Our Reference: CLA.D4.WQ2.AS1 Your Reference: TR010044

Response to ExA's Second Written Questions (WQ2) – Q2.11.2.1

Q2.11.2.1: Road design and layout

Figure 1: Applicant's General Arrangement and Longitudinal Section of Toseland Road [Extracted from APP-022].

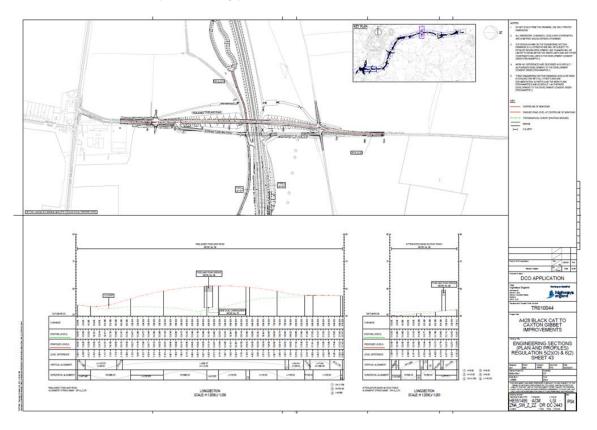
- The required Stopping Sight Distance (SSD) of 215m is achieved
- 2.2. Toseland Road has a smooth/straight alignment, see Figure 1 below; a low value of Bendiness degrees/km (approximated at 10 degrees/km) and a corresponding high value of Harmonic mean visibility means that the value of Ac will not exceed 8.

- 2.5. This means that it is not the cross-section element of layout constraint that places the greatest constraint on speed, but the alignment. Simply reducing the carriageway width to 6m does not necessarily reduce speed, a driver's perception of a safe speed is primarily determined by the alignment and the Applicant has designed the alignment to fully comply with standards. In fact, the predominant horizontal curvature of 2880m would be suitable for a design speed of 120kph. In other words, drivers will believe that at least 100kph is a safe speed based on the smooth alignment that provides more than the necessary visibility, so providing a narrow carriageway would be confusing.

Providing a non-compliant layout with a fully compliant alignment will actually make it less operationally safe not more. It is CCC's view that the Applicant's approach is flawed. If the Applicant was concerned that there was a road safety problem, then their approach should have been to introduce greater alignment constraint by increasing the change in direction along the proposed roads (increased 'bendiness') and reducing the harmonic mean visibility accordingly.

Figure 2: Applicant's General Arrangement and Longitudinal Section of B1046 and Potton Road Realignment [Extracted from APP-021]

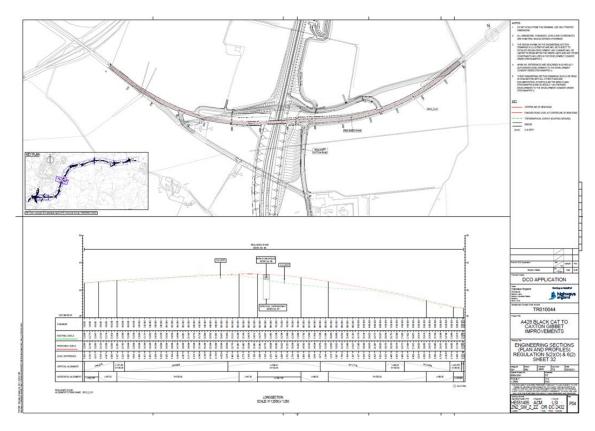
- The required Stopping Sight Distance (SSD) of 215m is achieved
- 2.10. Potton Road has a smooth/straight alignment, see Figure 2 below; a low value of Bendiness degrees/km (approximated at 10 degrees/km) and a corresponding high value of Harmonic mean visibility means that the value of Ac will not exceed 8. The net result is the same as at Toseland Road; a design speed of 100kph irrespective of the layout constraint.

- 2.11. The B1046 provides greater horizontal curvature with radii of 720m, but this is the desirable minimum for a design speed of 100kph. The Bendiness degrees/km (approximated at 22.5 degrees/km) and a corresponding high value of Harmonic mean visibility means that the value of Ac will not exceed 10.5. The net result is the same as at Toseland Road and Potton Road; a design speed of 100kph irrespective of the layout constraint.

- 2.12. As at Toseland Road, providing a non-compliant layout with a fully compliant alignment will actually make it less operationally safe not more, the Applicant's approach is flawed. If the Applicant was concerned that there was a road safety problem, then their approach should have been to introduce greater alignment constraint by increasing the change in direction along the proposed roads and reducing the harmonic mean visibility accordingly. However, this would require additional land take and increase the cost of the project.

Figure 9: Photo of B1046, NW of railway bridge. 6.8m carriageway, kerbed

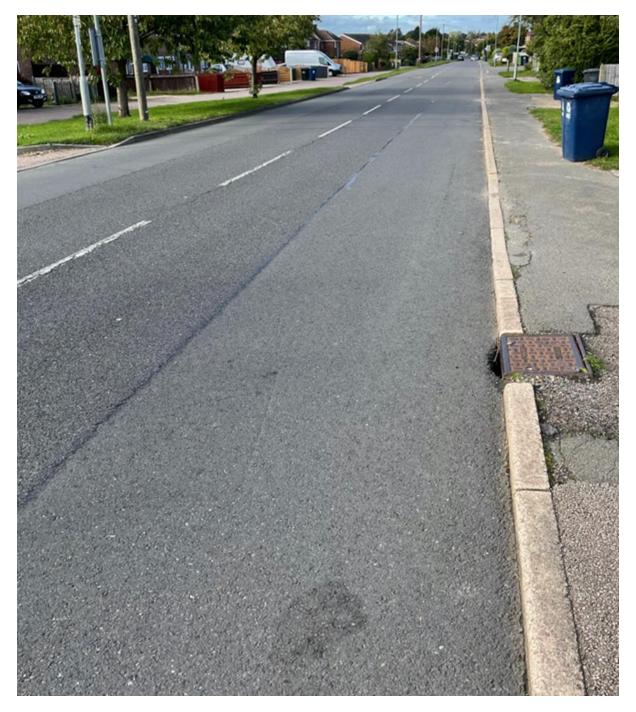
1.4. NW of rail bridge the existing road is 6.8m wide kerbed, with adjacent footways and housing. Side inlet gullies mean that gully pots are not in wheel track.
